Re: Turkey Point Units 3 and 4  
Docket Nos. 50-250 and 50-251  
Emergency Plan Implementing Procedure Revision

0-EPIP-20126, Offsite Dose Calculations

## **SUMMMARY OF CHANGES**

**ATTACHMENT 1**  
(Page 4 of 7)  
**METEOROLOGICAL DATA WORKSHEET**

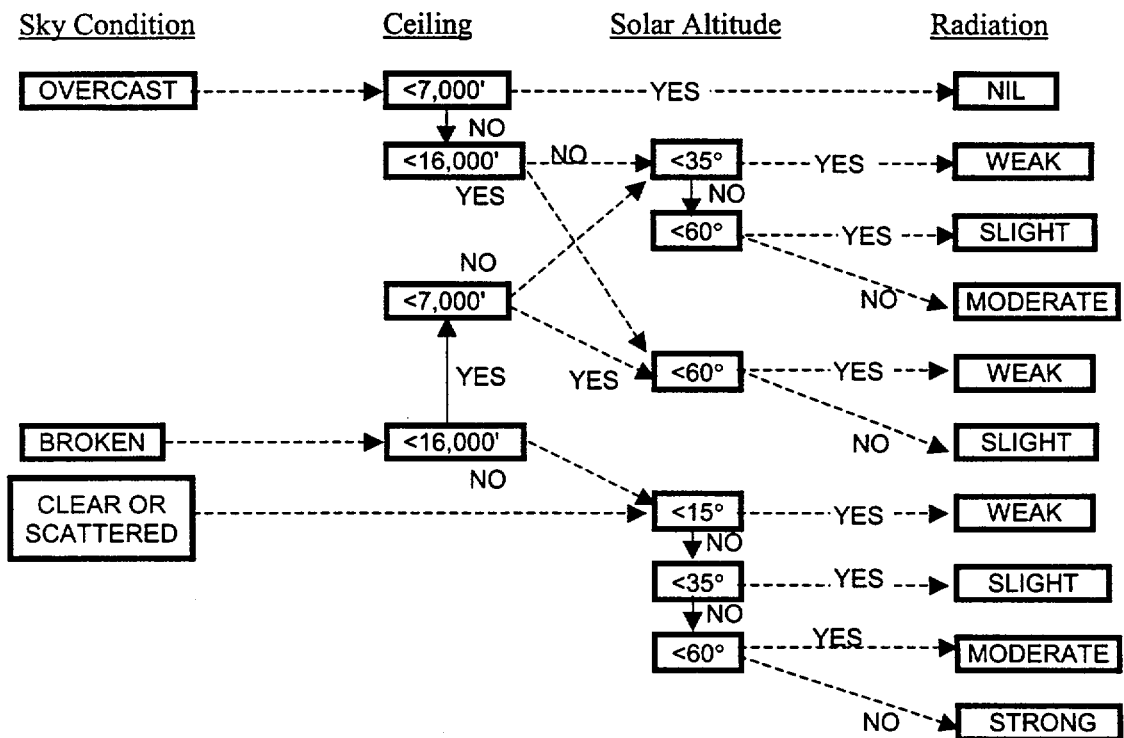
3. Page 20, change made to align procedure to LAN-based rather than stand-alone.
4. Page 24, step added to begin print function.
5. Page 31, Meteorological Data Worksheet, replaced with a better copy.
